Eugene S. Grecheck
Vice President
Nuclear Development

Serial No. NA3-08-121R
Docket No. 52-017
COL/MWH

DOMINION VIRGINIA POWER
NORTH ANNA UNIT 3 COMBINED LICENSE APPLICATION
RESPONSE TO REQUEST FOR ADDITIONAL INFORMATION LETTER 029 (FSAR
CHAPTERS 8 AND 16)

NAPS COL 8.2.4-1-A Figure 8.2-201 500/230 kV Switchyard Single-Line Diagram

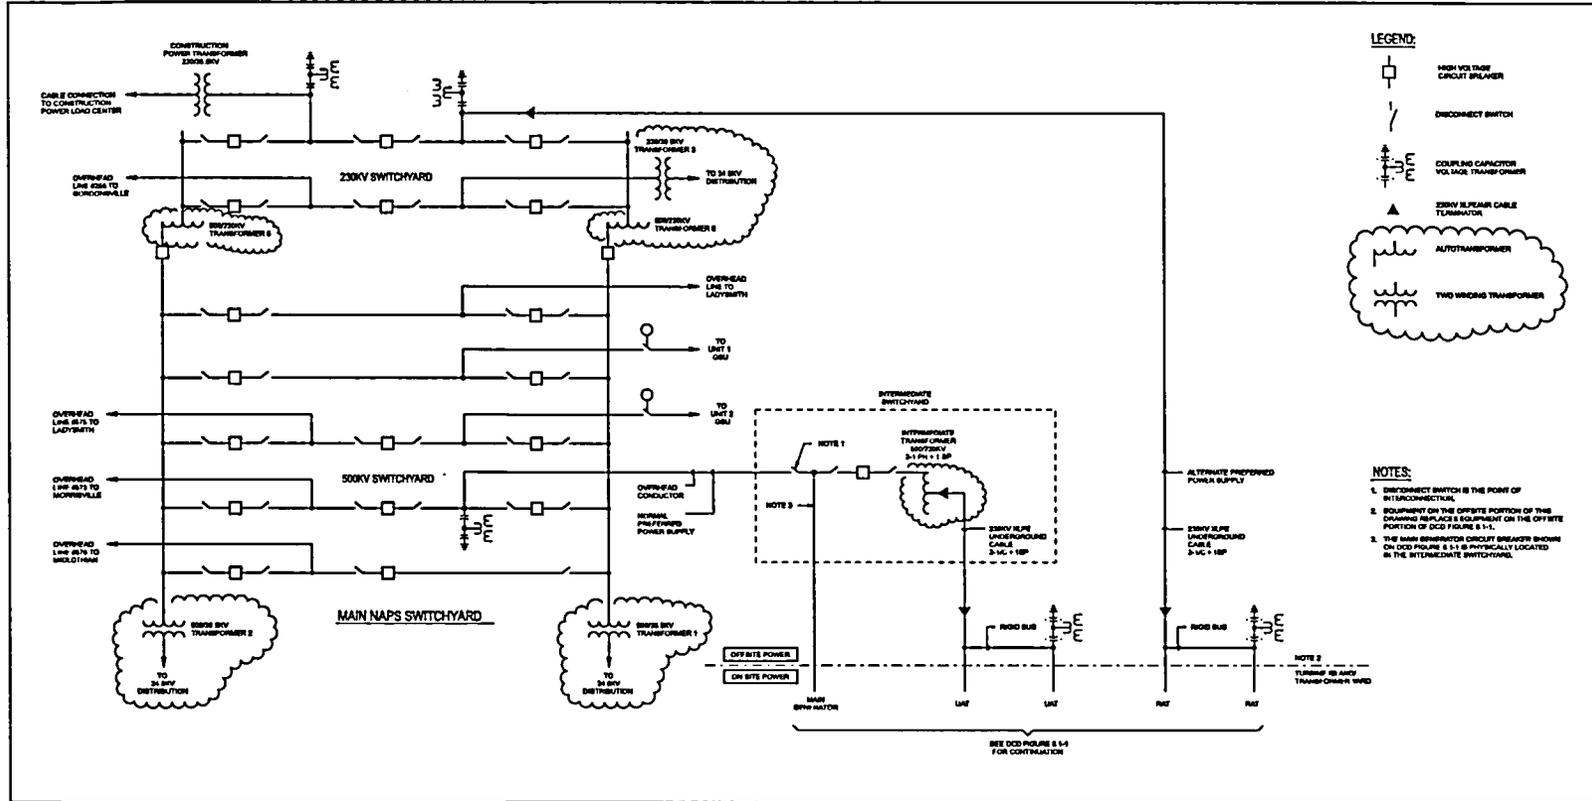
On the basis of its review, the staff finds that the applicant did not identify transformers 1, 2, 3, 5, and 6 in Figure 8.2-201. The staff requests that the applicant revise or supplement figure 8.2-201 accordingly.

FSAR Figure 8.2-201 will be revised to identify transformers 1, 2, 3, 5, and 6 as shown in the attached FSAR mark-up.

- FSAR Figure 8.2-201 will be revised as indicated on the attached markup.
